4-D-24-HZ
APPLICATION FOR CERTIFICATE OF APPROPRIATENESS

1704 Highland Ave. 37916
Ft. Sanders NC

Staff Report

File Number: 4-D-24-HZ

① SITE PLAN
 1/16" = 1'-0"

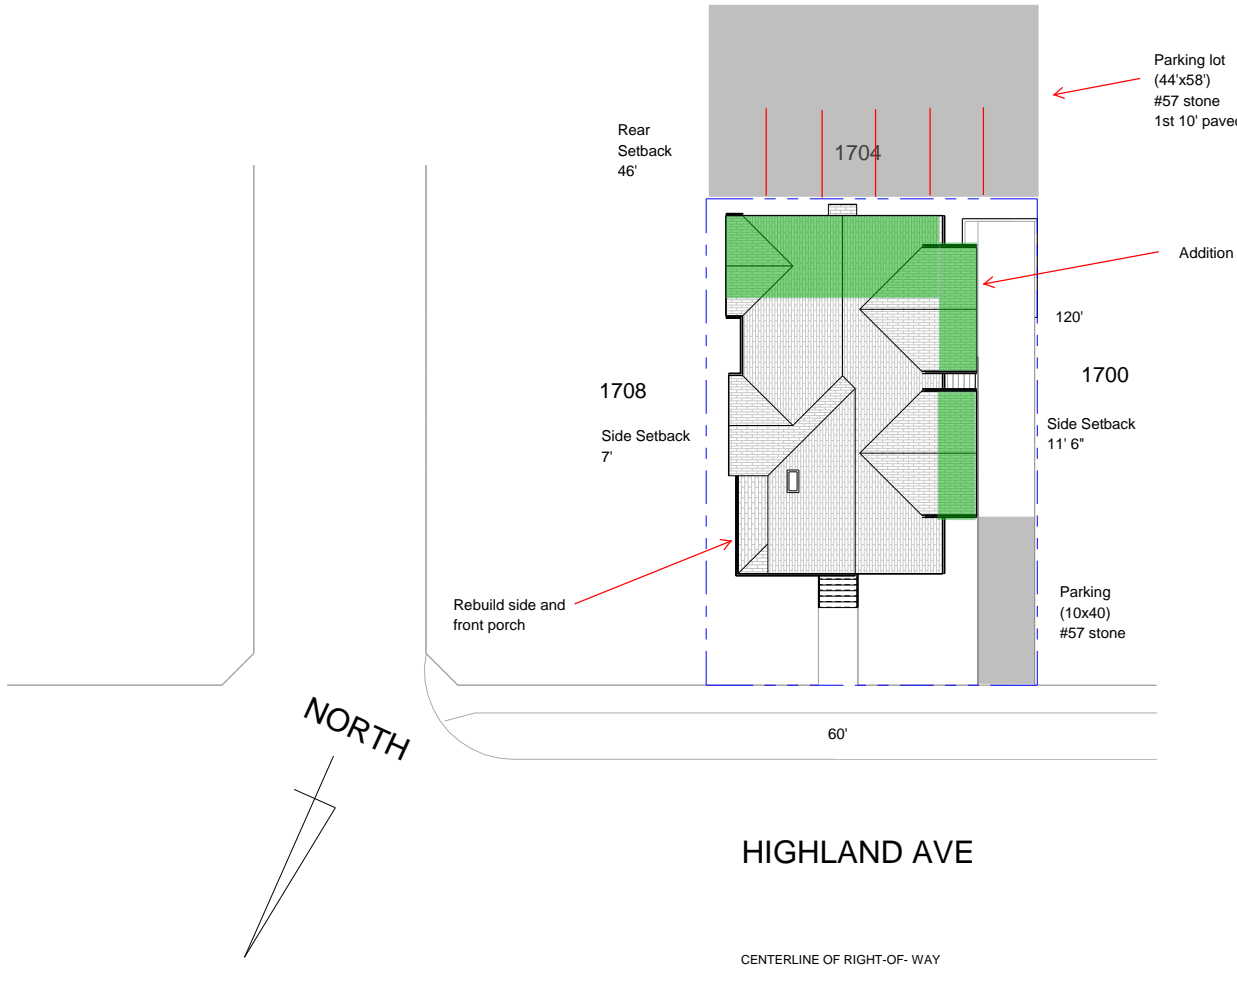
8. Front yard parking does not meet the design guidelines; the current front driveway is existing but may not meet Engineering standards. Final modifications to the site plan will be necessary to meet City Engineering standards for parking. The house and parking area should remain below the 45% impervious surface requirement for the zoning. The final site plan could be approved by staff, provided there are no substantial modifications to the addition's design and placement.

- 1) applicant to submit a revised roofline drawing, clearly showing the area to be reconstructed,
- 2) existing roof pitch on the main front gable massing to be retained;
- 3) replication of the original round fluted porch columns or installation of 10 by 10 square columns;
- 4) final drawings to indicate appropriately sized cornerboards and window trim;
- 5) final site plan to meet City Engineering standards and requirements of the base zoning code.

Owner	
Project Name	
FLOOR PLANS	
Project Number	Project Number
Date	Issue Date
Drawn By	Author
Checked By	Checker
A202	
Scale	1/8" = 1'-0"

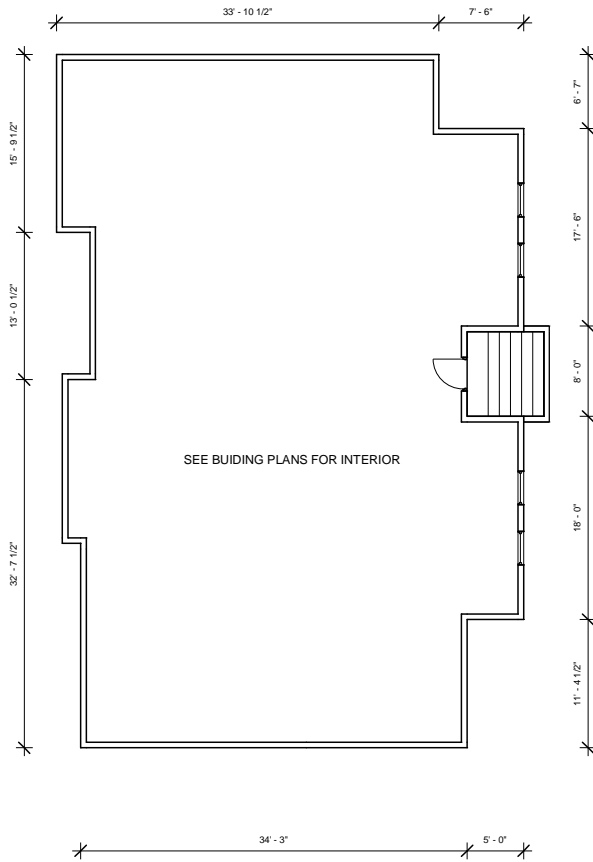
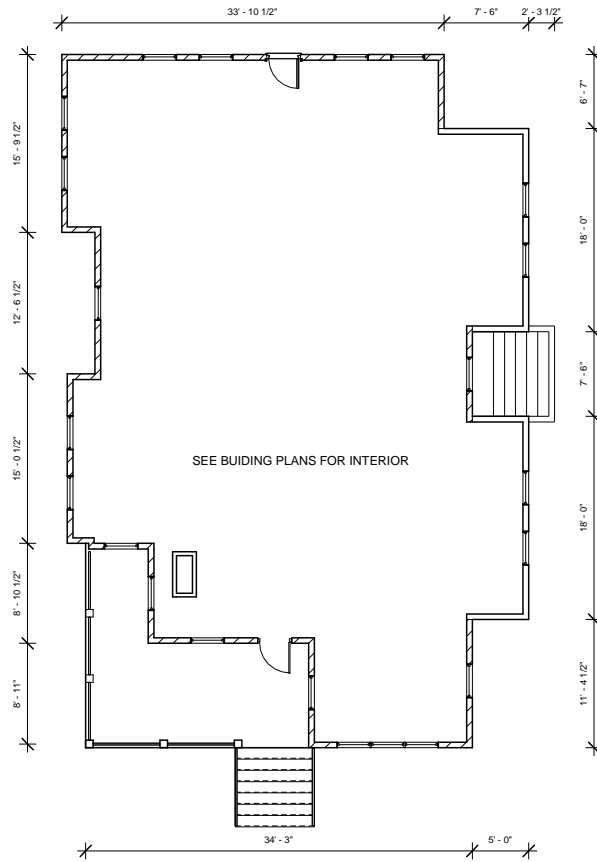
4. Some window openings may be shifted and new openings will be installed on the side and rear elevations. Overall, the revised window placement is evenly spaced and the proportions meet the design guidelines.
